DOOSAN Document Transmittal Upper Trishuli-1 HEP (216MW)		Date 2022-03-10	DT No.: UT1-HEP-DHI-PC-D-0013	SHEET 1 OF 1
DOOSAN NEPAL BRANCH OFFICE	Address & Contact No. : Four Square Building, Naxal, Kathmandu, Nepal (P.O Box : 1387) + 977 1 692 3014	Project No. H20002	DOCUMENT DISPATCHED BY Courier Service ☐ Messenger ☐ Post-Air Freight ☐ Document System or E-mail ■ By hand ■	
DOCUMENT DISTRIBUTION	■ POWER CHINA (Subcontractor) ☐ Doosan's Site Office			
SUBJECT	Review Note RN-0081_Layout of Access Tunnel for DS gate operating House of Desander

UPPER TRISHULI-1 HEP (216MW)

REVIEW NOTE

Contractor	**Doosan Heavy Industries & Construction Co., Ltd.**		
Title of the Document	Layout drawing of access tunnel for DS gate operating house of desander, sheets 1-2		
Document No.	UT1-C-030-CVL-DG-51001	Revision	0A
Date of Documents	12.08.2021	Received Date	19.08.2021
Transmittal Form No.	UT1-HEP-DHI-D-0032		
Previous Review Date/Status	N/A	Prev. Review Note No.	N/A
Review Note No.	**RN-0081**	**Present Review Date**	**08.03.2022**
		Present Review Status	**FI**

GENERAL PLAN OF ACCESS TUNNEL FOR D/S GATE OPERATING HOUSE OF DESANDER BASIN

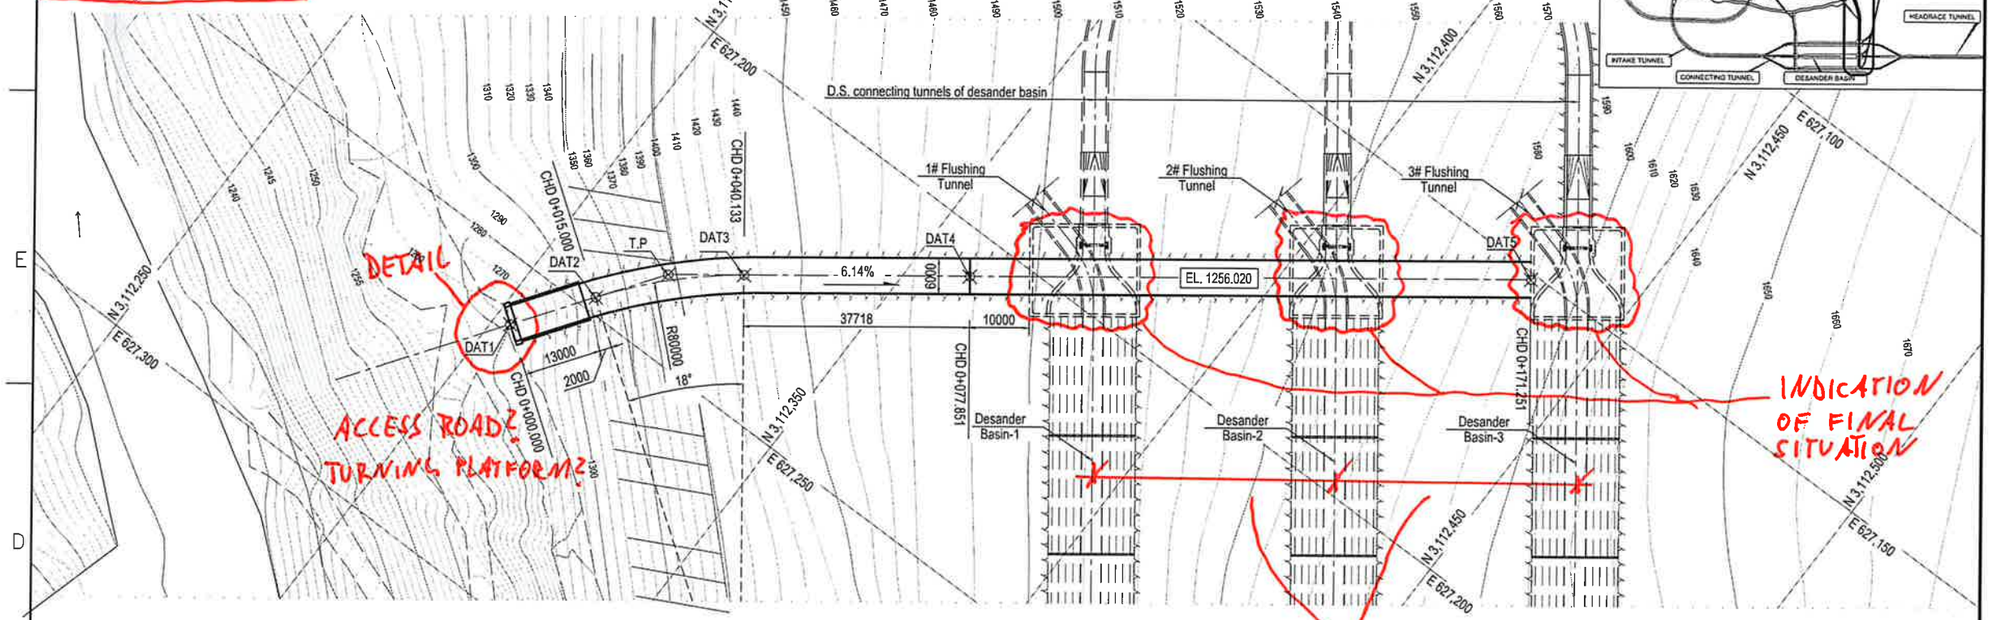
ALREADY IN TITLE BLOCK

TYP. SECTION OF D.S. ACCESS TUNNEL FOR ROCK I, II, IIIa AND IIIb

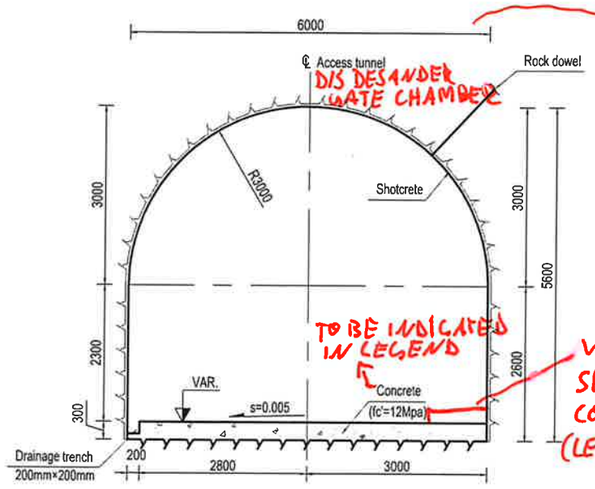
1st stage concrete
↳ CLASS/STRENGTH TO BE INDICATED/ REINFORCED?

TYP. SECTION OF D.S. ACCESS TUNNEL FOR PORTAL AND ROCK IV, V

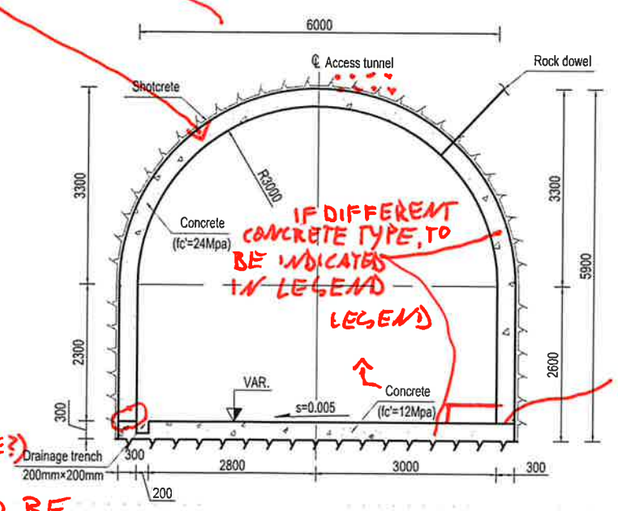
SAME EXCAVATION DIMENSIONS?

- DIMENSIONS HAVE TO BE CONFIRMED BY SUPPLIER (E.G. GATE TRANSPORTATION)
- IN GENERAL LAYOUT DRAWINGS ALL INFRASTRUCTURE (CABLE WAYS, PIPES, ...) SHALL BE SHOWN

LONGITUDINAL PROFILE OF ACCESS TUNNEL FOR D/S GATE OPERATING HOUSE OF DESANDER BASIN

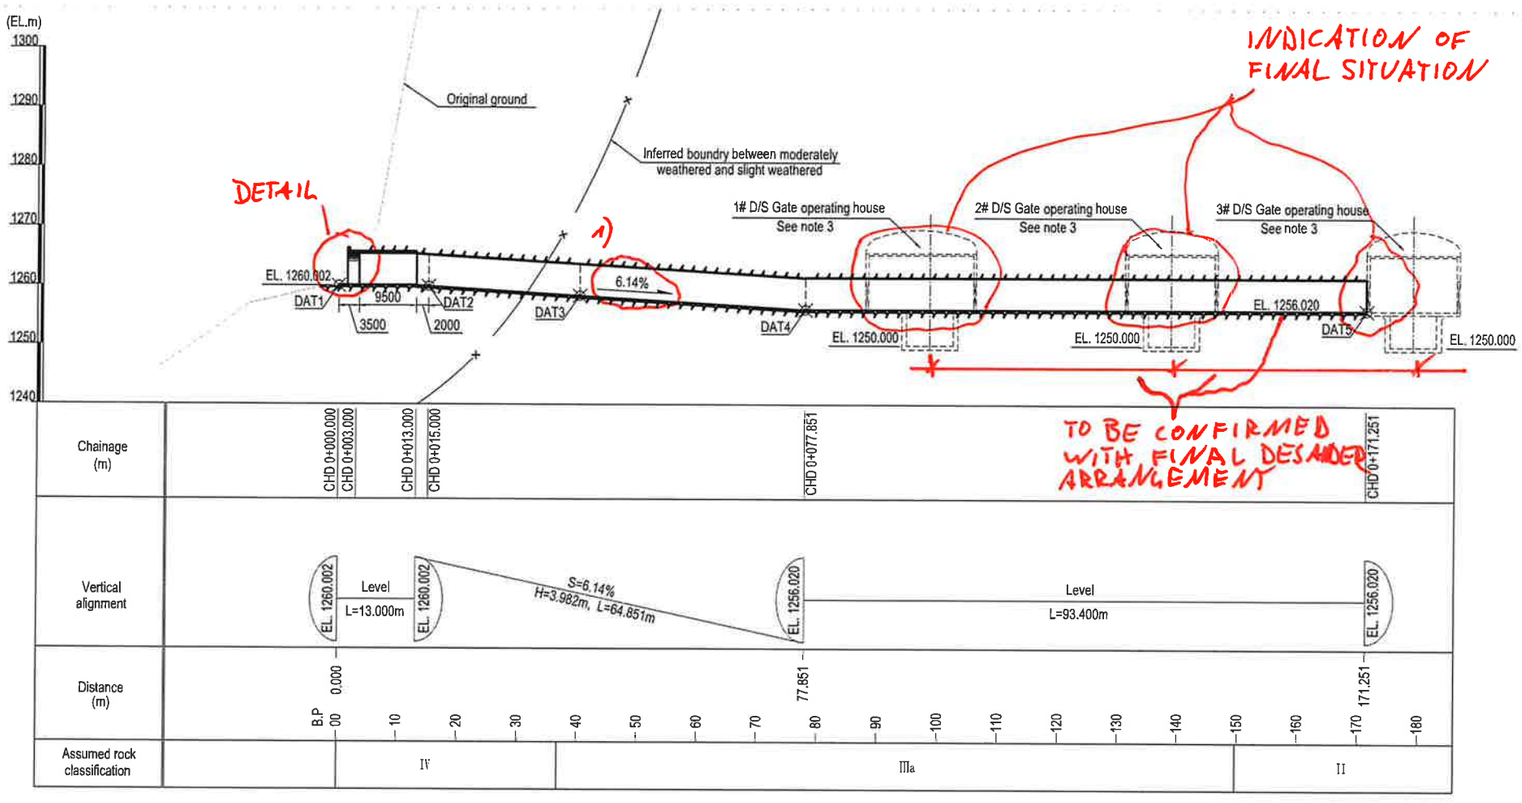
TO BE CONFIRMED WITH FINAL DESANDER ARR.

1) AS THE TUNNEL DESCENTS INTO THE MOUNTAIN, DRAINAGE SYSTEM BY GRAVITY (E.G. VIA DESANDER FLUSHING TUNNEL) SHALL BE CONSIDERED.

NO!

COMMENTS OF SHEET 1/2 AR APPLICABLE
